ADDENDUM NO. 1

October 7, 2026

CORNELL UNIVERSITY
BEEBE HALL CU MAKER HUB RENOVATIONS
110 ARBORETUM RD.,
ITHACA, NY 14850

FLOOR PLAN- LEVEL
02

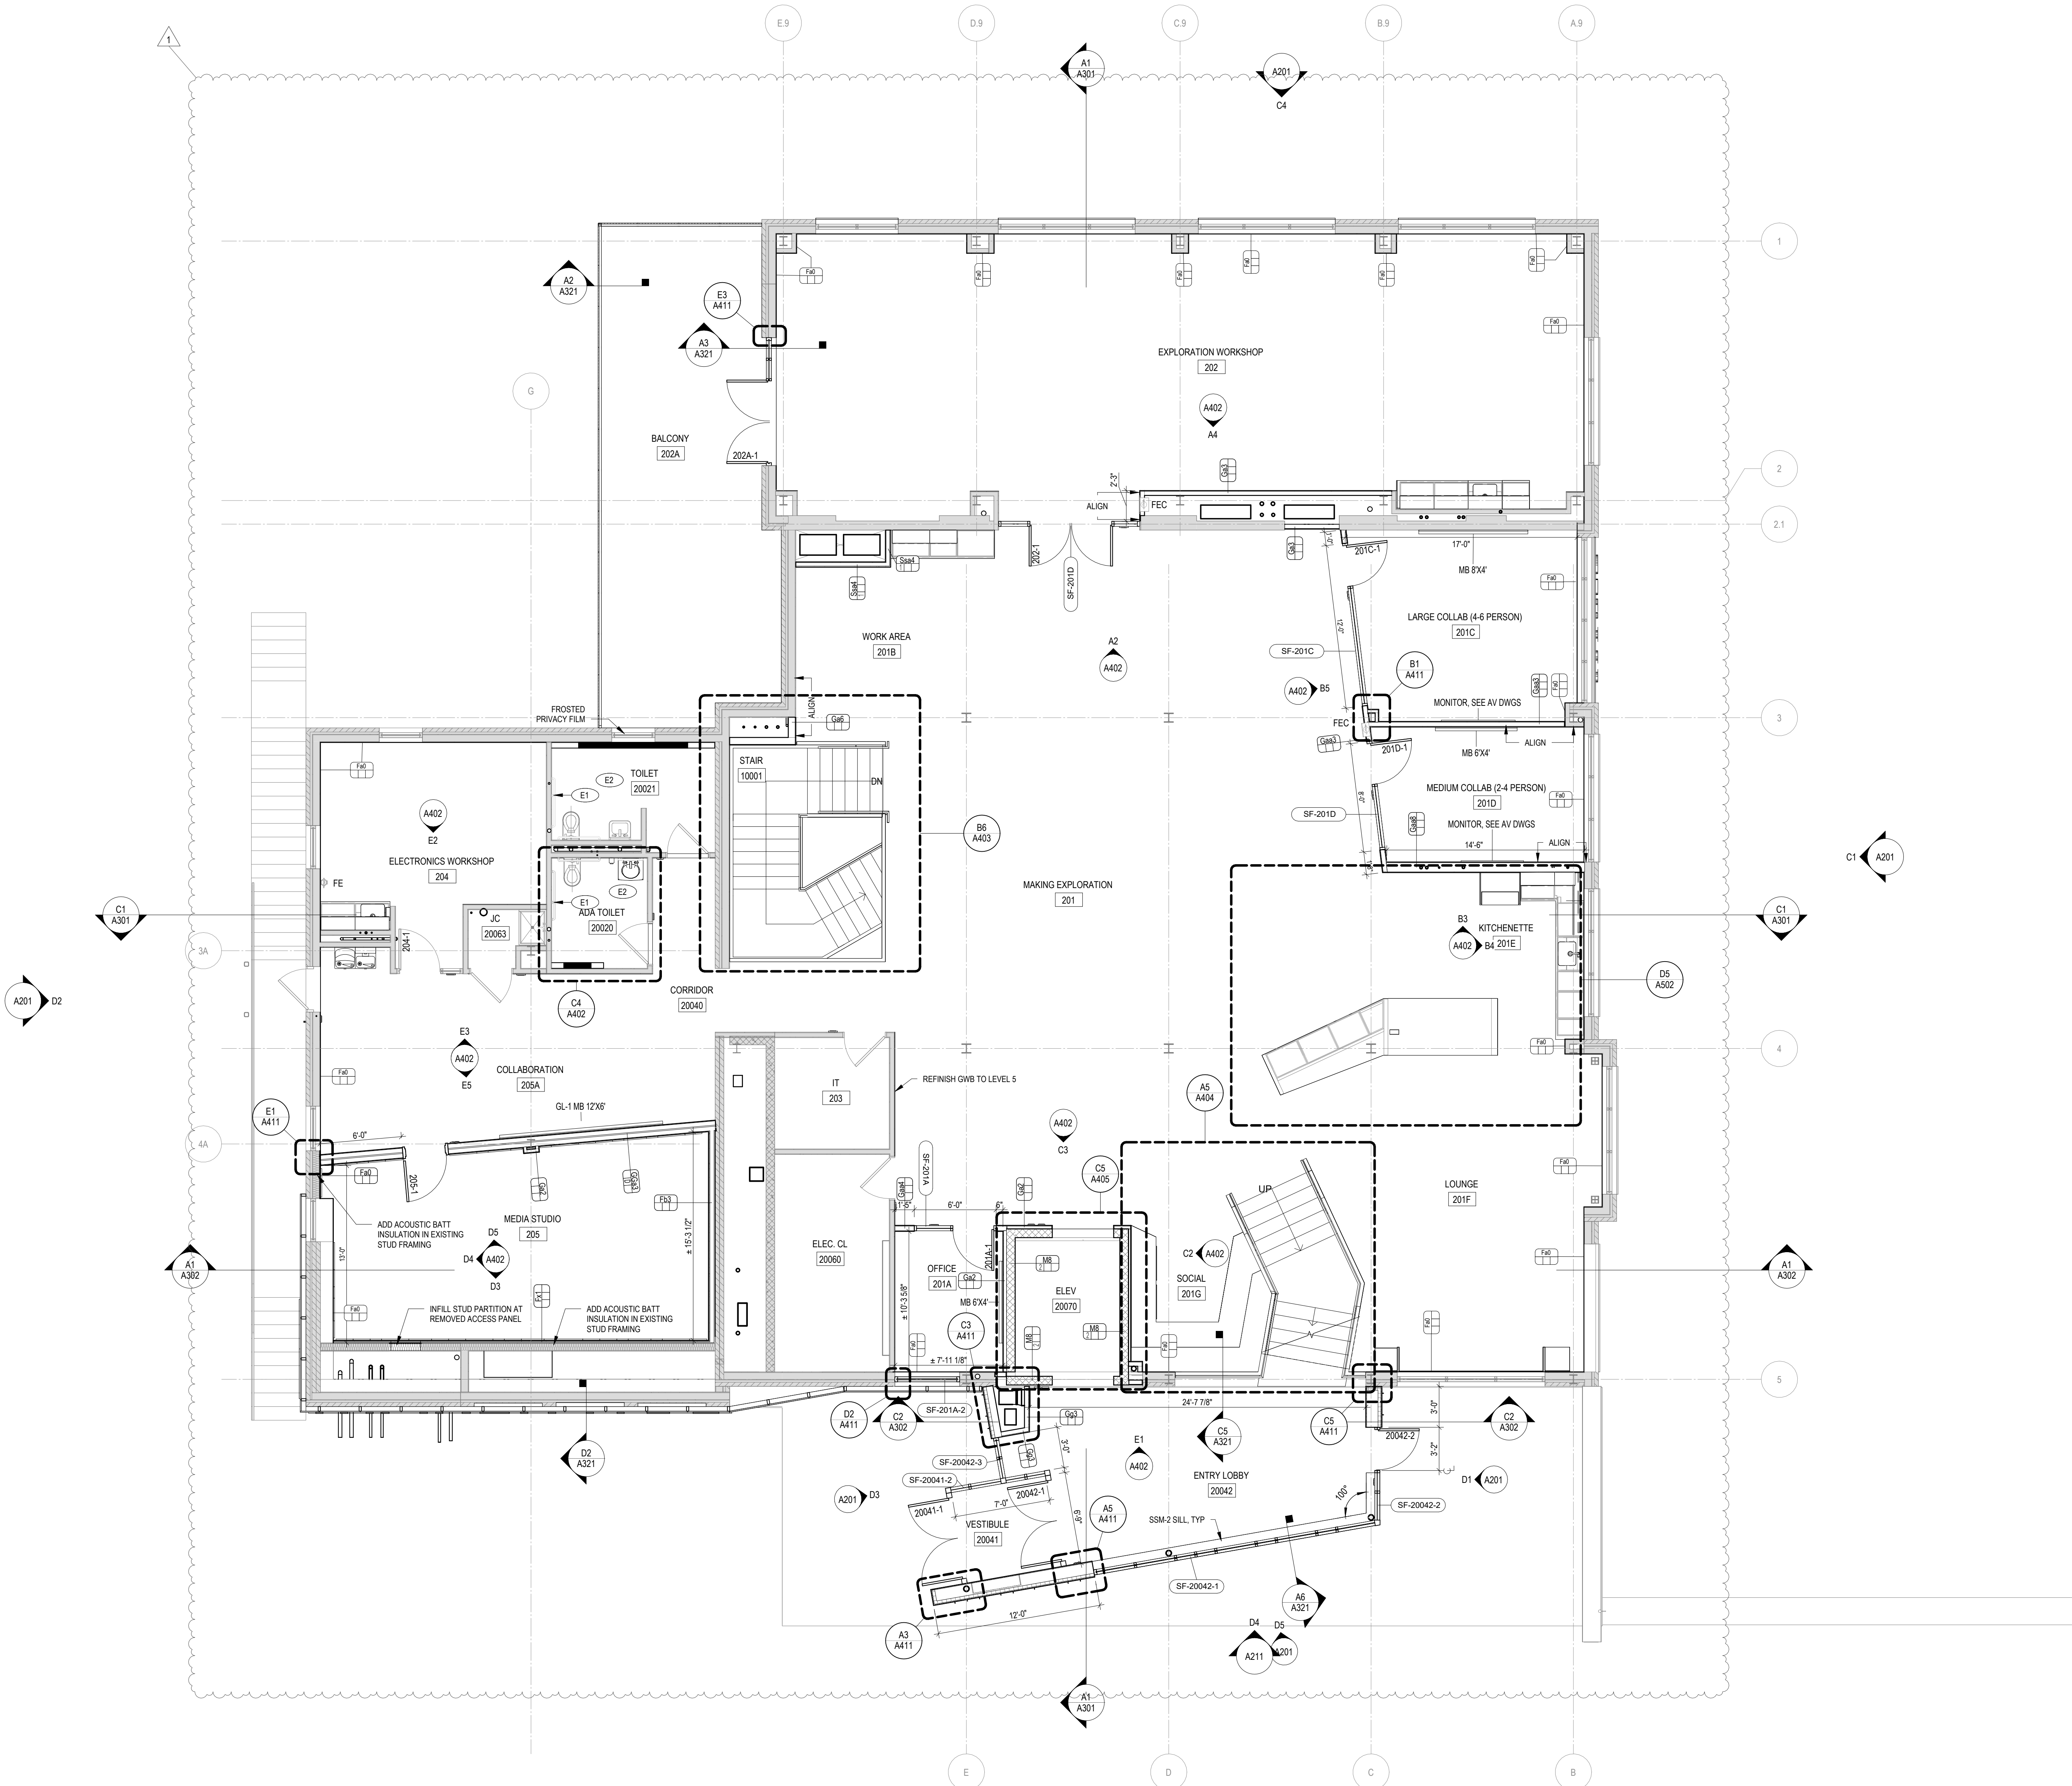
5	A102		What is the size of the acoustically rated access panel in room 205 Media Stuidio	See Addendum No. 1, Item 12. Access panel in room 205 Media Studio has been deleted.
6	A621		Please confirm that there are no Stainless Steel Corner Guards(Note 4 on Finish Schedule) required on Level 02	No corner guards are required on Level 02. Provide corner guards only in rooms where note 4 is indicated on finish schedule.
7	A121		Dteail E4 on A121 is shown in the Mechaincal Room 10060. Please confirm that this is the only place where a spring isolated ceiling is is required.	The spring isolated ceiling system detailed E4 on A121 is to be applied to the entire Mechanical Room 10060 only.
8	Section 07 4623		Please provide a spec for the wood plank ceiling , and wood slat soffit	See Addendum No. 1, Item 5. This new Section covers the material to be used for the wood plank ceiling and wood slat soffit.
